**PREESE HALL
SHALE GAS FRACTURING
REVIEW & RECOMMENDATIONS
FOR
INDUCED SEISMIC MITIGATION**

We have been asked by DECC to review these reports, and the further studies and information provided by Cuadrilla; and to make appropriate recommendations for the mitigation of seismic risks in the conduct of future hydraulic fracture operations for shale gas.

Figure 1: Graphs showing a) variations of analysed parameters with depth and b) overlay prefrac surface treating pressure plots.

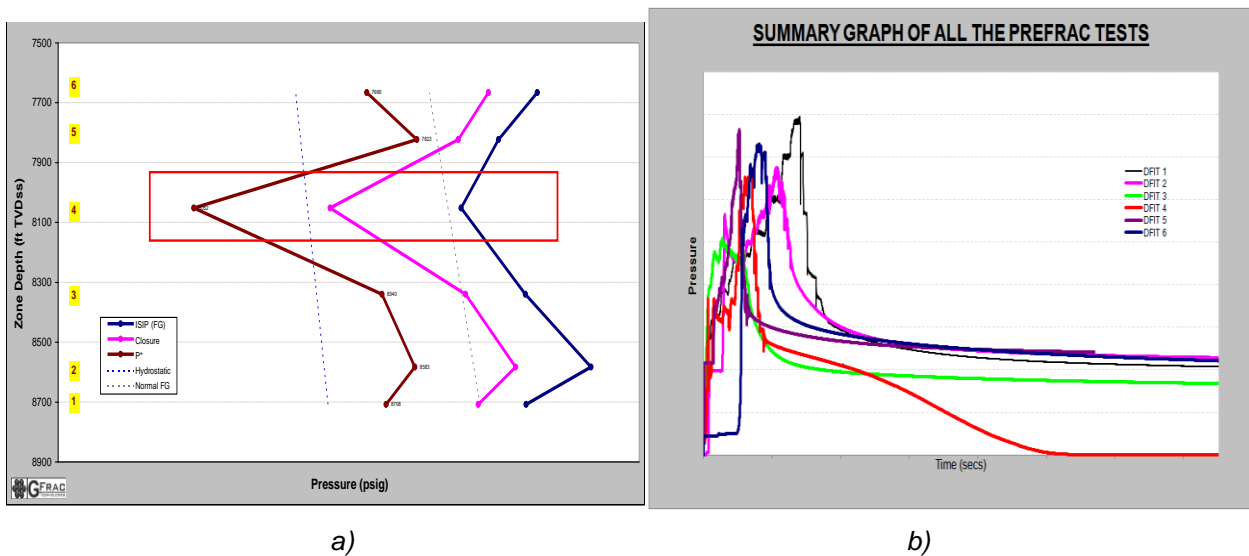
The plots of the treatment variations with depth are shown in Figures 1a) and 1b) and the only obviously exceptional zone is zone 4, as highlighted in Figure 1a. Zone 4 prefrac injection test analysis indicates that the fracture grew into a much lower stress zone and exhibited "fracture height recession" type leak-off characteristics, here probably representing the created fracture being forced into high-stress impermeable layers, which are forced to close first. We interpret this as possibly being at, or very near, to the fault, which is then proposed as a possible explanation of the subsequent immediate seismic events, while injecting into zones 4 and 5.

Figure 2: Graph showing fracture gradient vs closure gradient relationship.

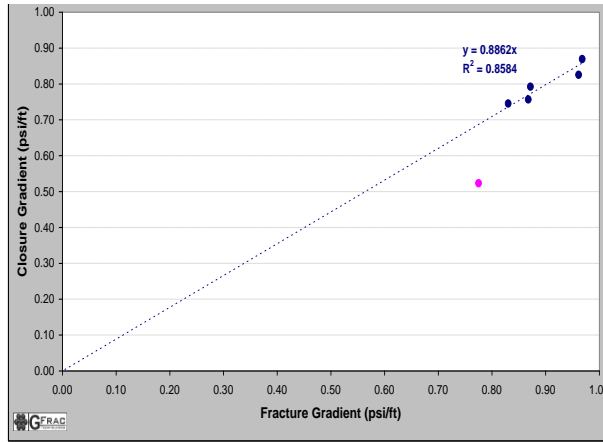
Overall, the results indicate distinct and separate behaviours for each zone, interpreted as being representative of good containment of the created fracture growth in each zone. However, we consider that there is little additional useful information that can be concluded about the resultant fracture growth using only the surface job data, given the lack of complementary diagnostics.

Figure 3: Woodford shale measured fracture heights compared to aquifer depths (copyright SPE)

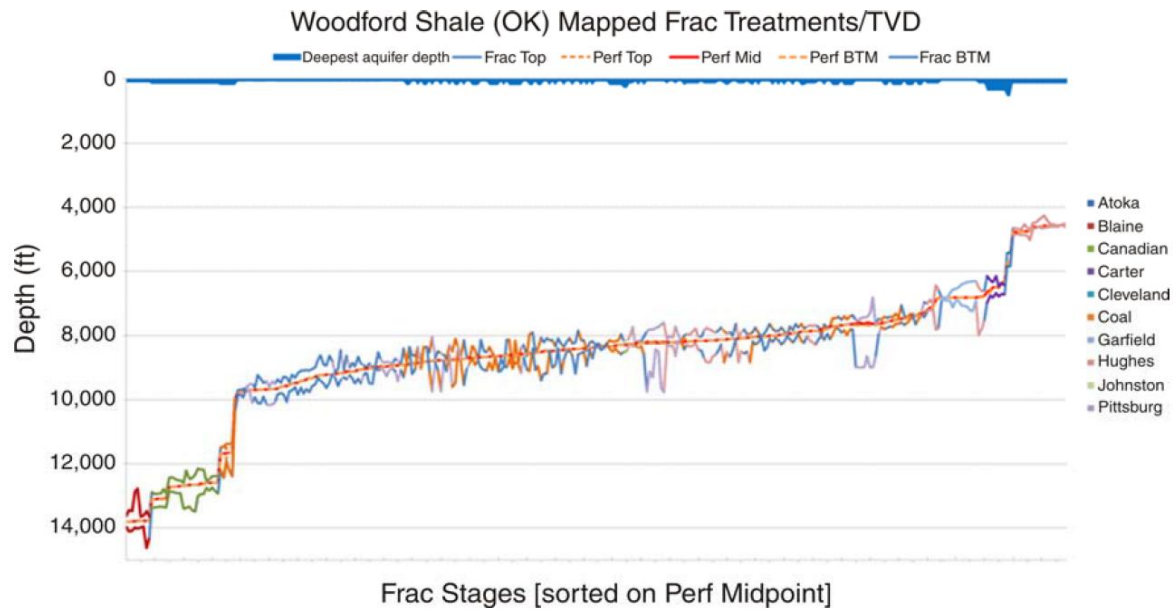
One of the major concerns with shale gas developments is answering the question of how the created hydraulic fracture grew, particularly in relation to shallower aquifers. A summary of US microseismic and tiltmeter data in shales has recently been published (Fisher and Warpinski, 2011) based on treatments carried out in the Barnett, Woodford, Marcellus and Eagle Ford shales. This work is of particular interest as it summarises how the fractures grew with respect to the overlying aquifers. Overall, the data indicate that in general for deeper shales (here classified as >4000ft TVD_{SS}), the created hydraulic fractures remain well confined to the target interval, even in the presence of faults, (see Figure 3 and also Figures 4-6).

Overall, the US data indicates that faults do not provide a mechanism whereby created fractures are able to propagate significantly upwards, towards the surface. The presence of faults is generally indicated by large upward and downward growth spikes, but overall vertical growth is still limited to several hundreds of feet. The Woodford shale is probably the best analogue for the Bowland shale, as it also has a very complex geology which also includes faulting and highly dipping or overturned bedding planes. However, interpretation of the

Woodford, in common with the Barnett, shows that created hydraulic fracture heights are well contained and separated from the local aquifers by at least several thousand feet. (In US regulatory practice, the focus would be on protection of aquifers used, or potentially usable, for drinking water supplies. It is our understanding that in the UK, the Environment Agency would aim to secure appropriate protection of all groundwater.)
